Sydney Biomedical Accelerator

State Significant Development Assessment Report (SSD-55388456)

November 2024

Figure 12 | Northern elevation (approved CIP envelope dashed orange) (source: RF12)

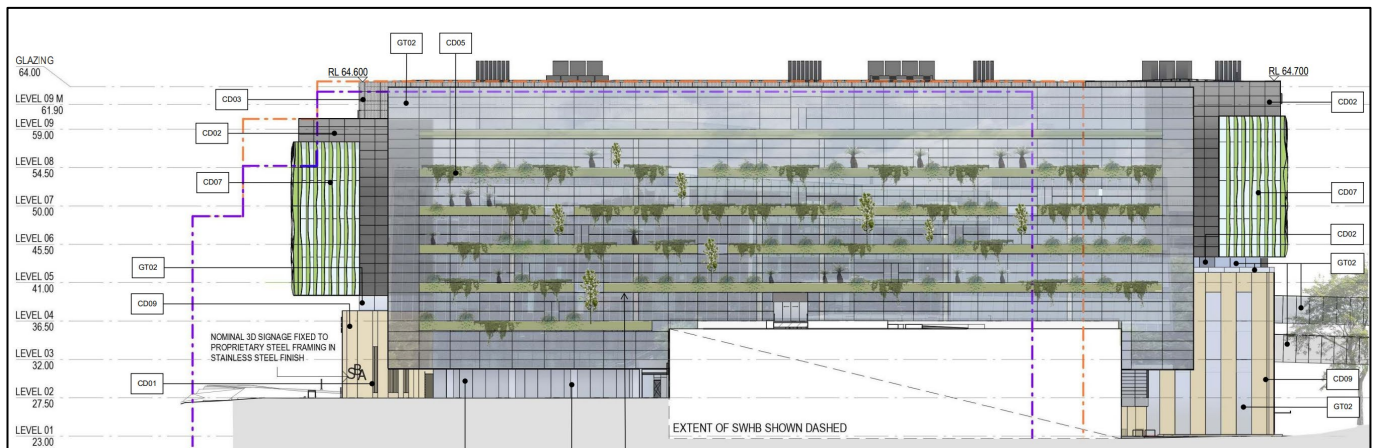
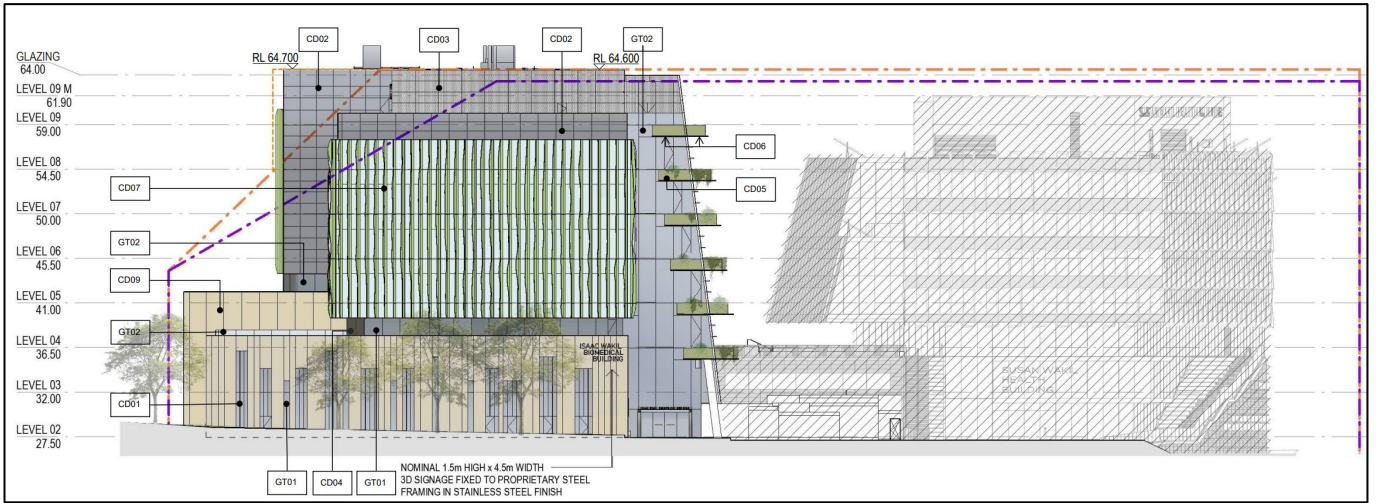
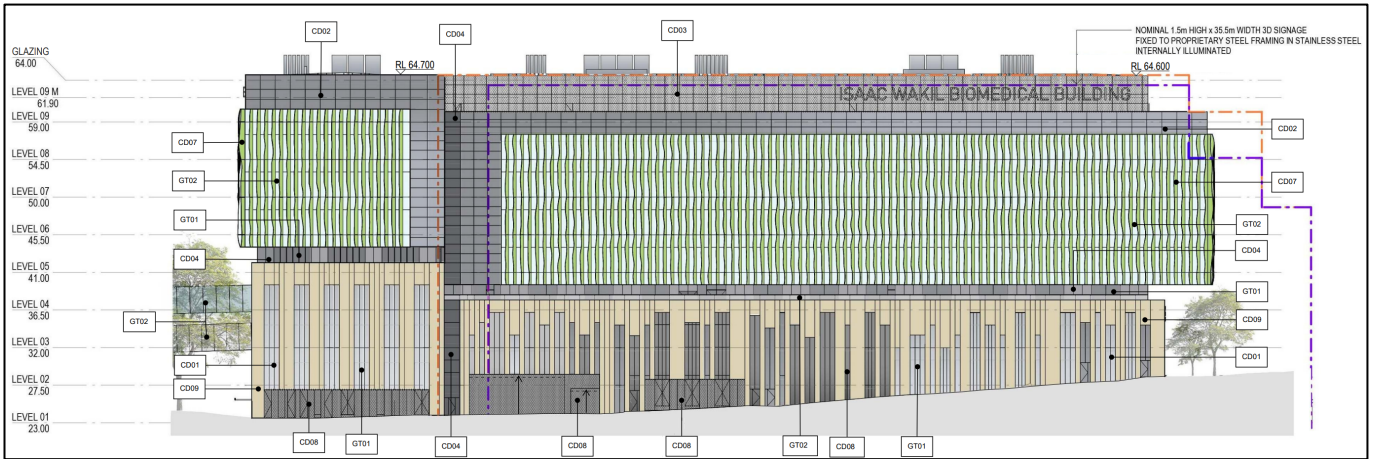
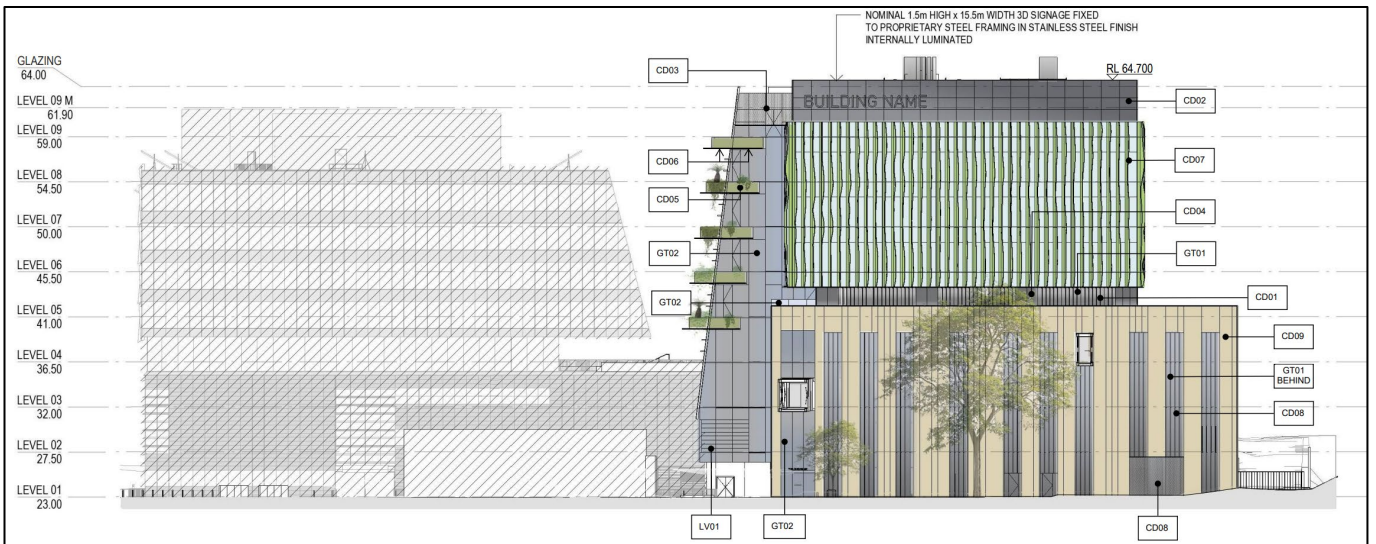
The portion of the building located on the RPAH land is not subject to any planning controls. The proposal seeks approval for a new nine storey building above ground (including plant), with a maximum building height 44.5 metres (RL64.7) to the top of the parapet across both the CIP controlled area and the RPAH land (see **Figures 10 and 11**) and a total maximum GFA of 36,580sqm, of which, approximately 28,900sqm is located on the CIP part of the site.

The Department has carefully considered the proposed building and is satisfied that the proposal is consistent with the approved CIP concept proposal. The proposed building is wholly contained

Figure 19 | Landscape design (source: RtS)

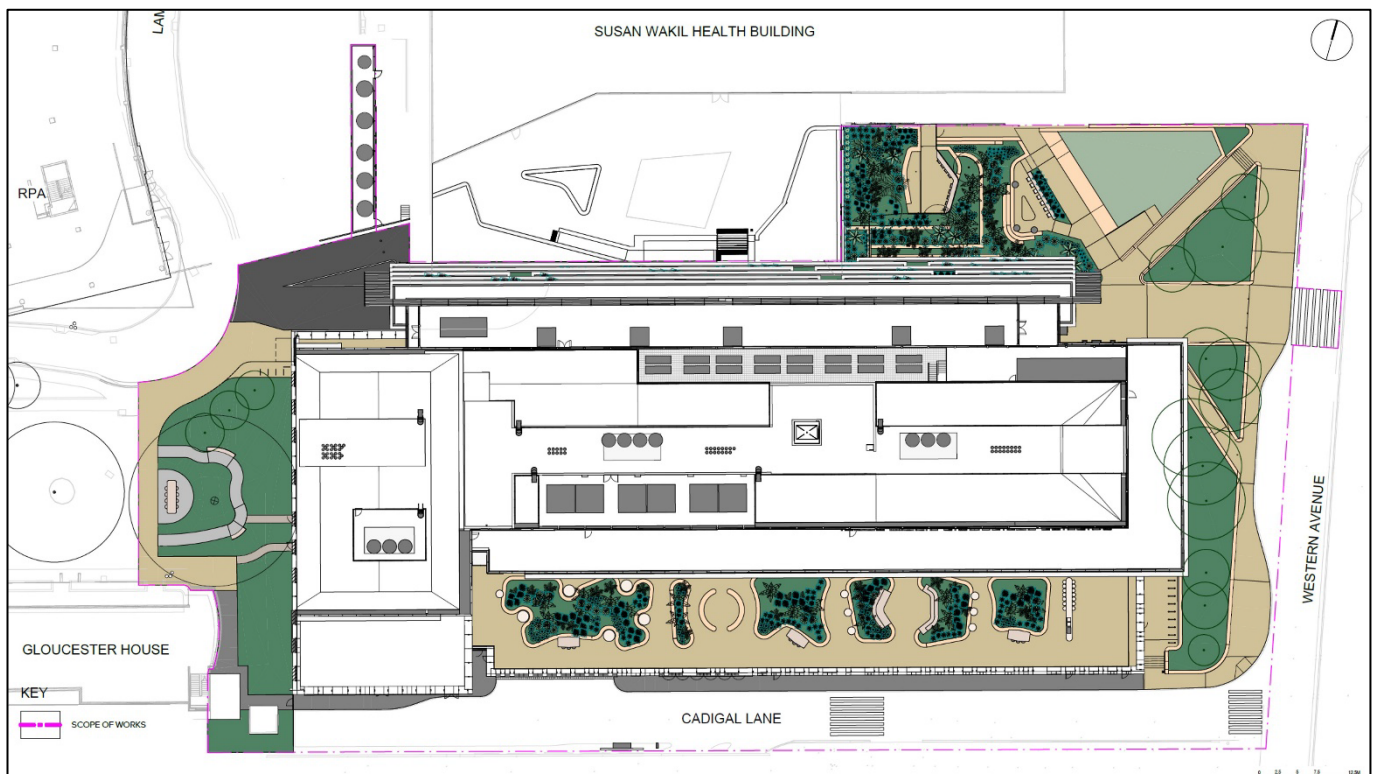
Council raised issues regarding the detail provided regarding the landscaping, including viability and longevity of the plantings and tree canopy. Council reiterated its comments in response to the RtS, which included a more detailed landscape plan, in relation to soil depths and volumes for the landscaping, encroachments on tree protection zones, extent of pruning for construction and canopy cover from the proposed 15 trees.

The Applicant provided further information identifying that the site had a canopy coverage of 1,020sqm (11.9 per cent) prior to the recent demolition works. The Applicant has also advised that the University's sustainability vision and target is to enable a greater canopy cover over the Camperdown campus, which is incorporated in its *University of Sydney Sustainability Strategy 2020 Strategy* and sets a goal of 30 per cent canopy cover by 2030 for the Camperdown campus.

The Department is satisfied that the landscaping is generally consistent with the approved CIP, as:

Figure 20 | Flood hazard levels, 1% AEP event (Source: FA)

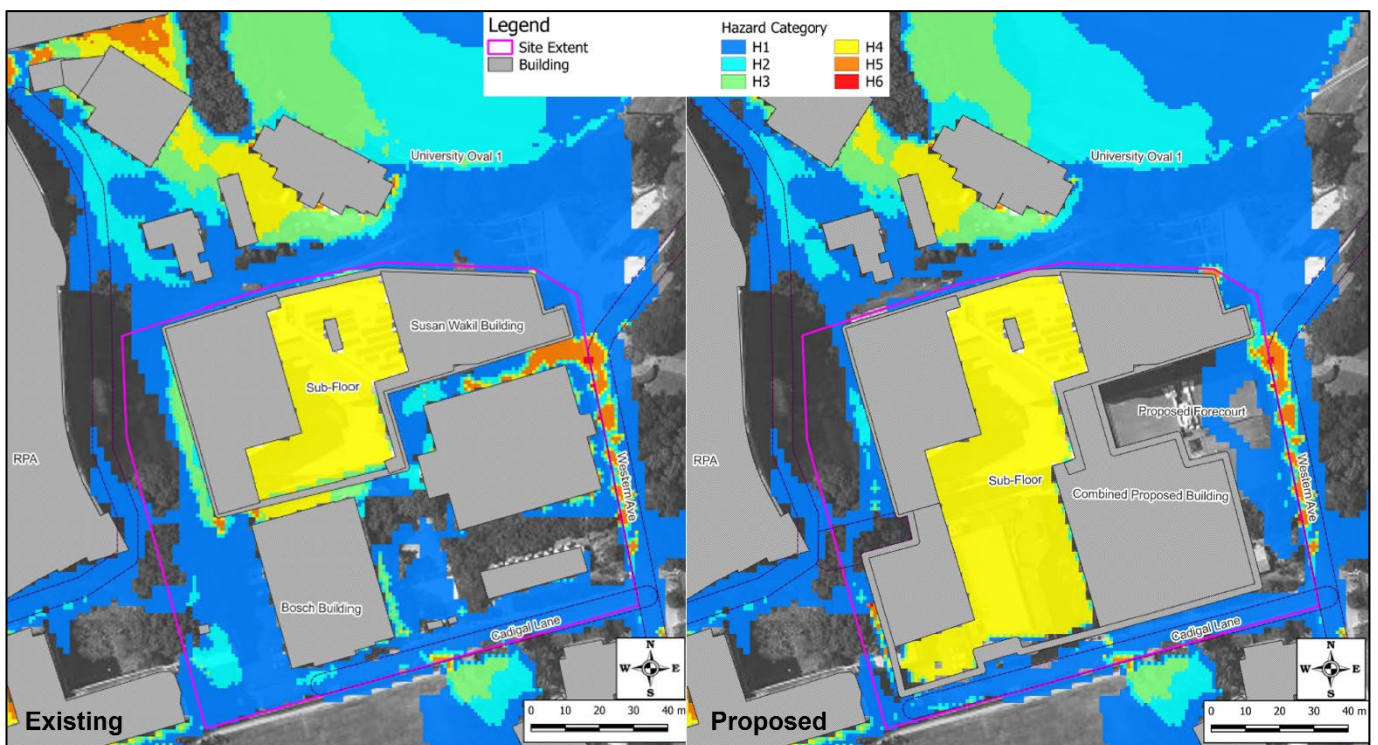
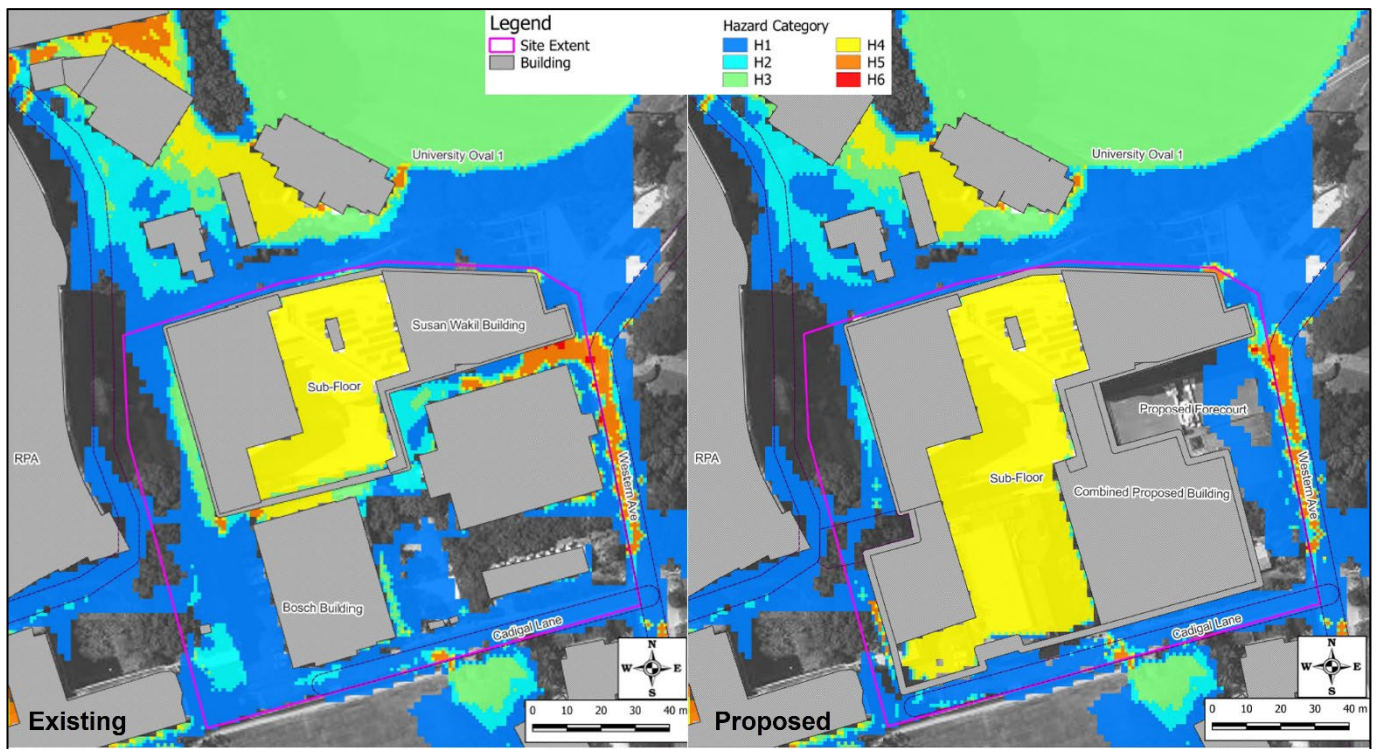
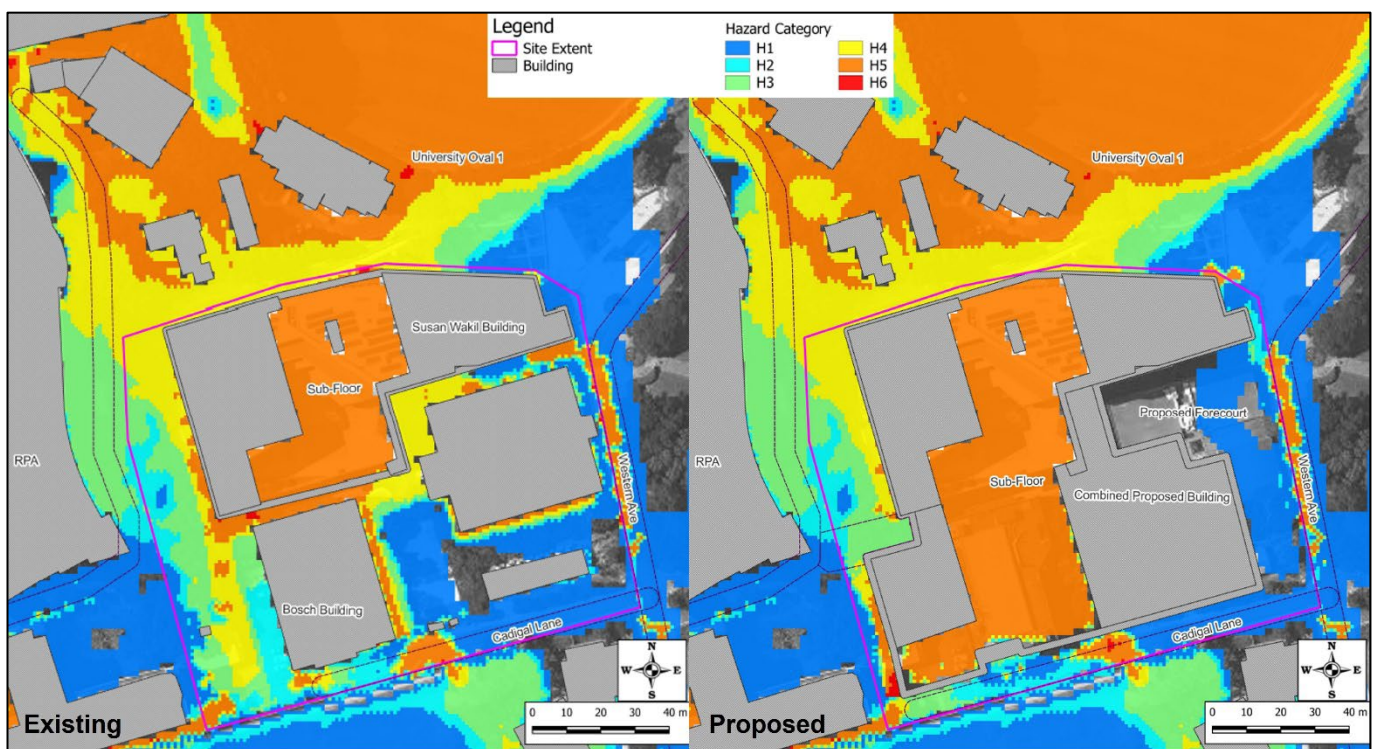
BCS and NSW SES noted several issues with the FA and requested a revised FA be prepared, including further consideration of cumulative impacts, PMF impacts, modelling details, impacts on the loading dock, use of Western Avenue carpark as flood storage, substation levels and impacts on surrounding streets. NSW SES also noted that the site is impacted by short duration overland flows as frequently as a 10% AEP event and may become isolated by floodwater in a 5% AEP event. Council raised flooding impacts and proposed mitigation measures for the loading dock.

The Applicant submitted a revised FA in the RtS and further flood information in RF12 that confirmed that the selected flood planning level and use of the sub-basement of the development to convey overland flow and provide flood storage would sufficiently address potential flood impacts. A structural statement prepared by a structural engineer was also provided in RF12 to confirm that the building has been designed to withstand flood impacts and transfer flow.

The revised FA confirms that the project would provide a more effective overland flow path through the site when compared to the pre-development scenario. It would do so by transferring a proportion of Cadigal Lane flows to the proposed sub-floor basement that meets the existing basement under the current SWHB to the north and the overland flow path that transfers flows in excess of inlet capacity north towards the flood detention basin at the oval. Specifically, the revised FA identifies the project would result in the following key changes to flood levels off-site:

The Department is satisfied the Applicant has demonstrated the flood impacts of the development are acceptable, noting:

Figure 23 | Level 1 floorplan

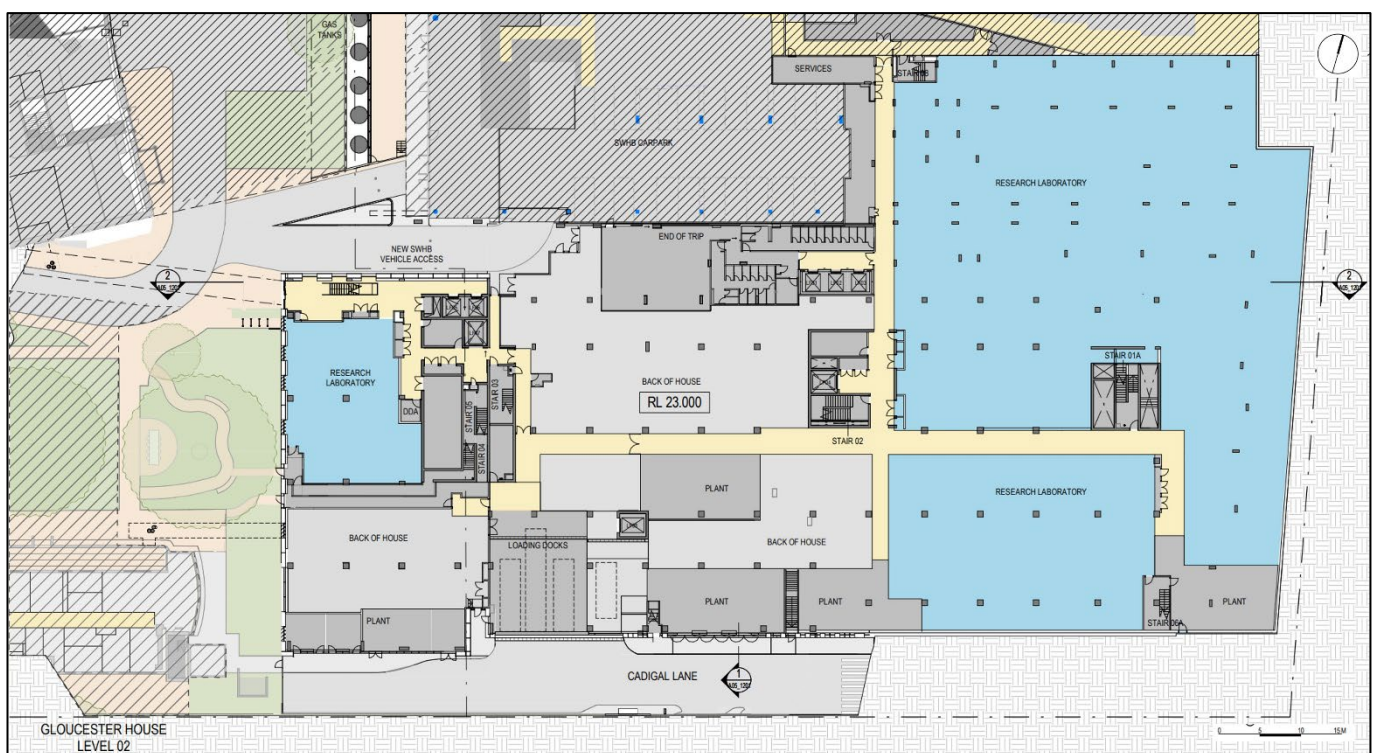
Council recommends that legal access to the site via Lambie Lew Drive must be established and maintained in perpetuity. Transport for NSW raised no issues with regard to the diverted traffic.

Council supported the new loading dock but advised a loading and servicing plan is required due to potential impacts on adjoining laneway (particularly pedestrians) if there are more than four trucks using the bay at any time. It also raised the potential pedestrian and vehicle conflict at Cadigal Lane and requested a RSA and restrictions for loading dock during peak periods, wider footpath, diversion of pedestrian traffic and signage.

- preparing a loading dock management plan (LDMP).
- installation of a fence at the end of Cadigal Lane to prevent pedestrian access through to RPAH and Gloucester House.
- installation of signage to warn pedestrians about the loading dock area and reversing vehicles.
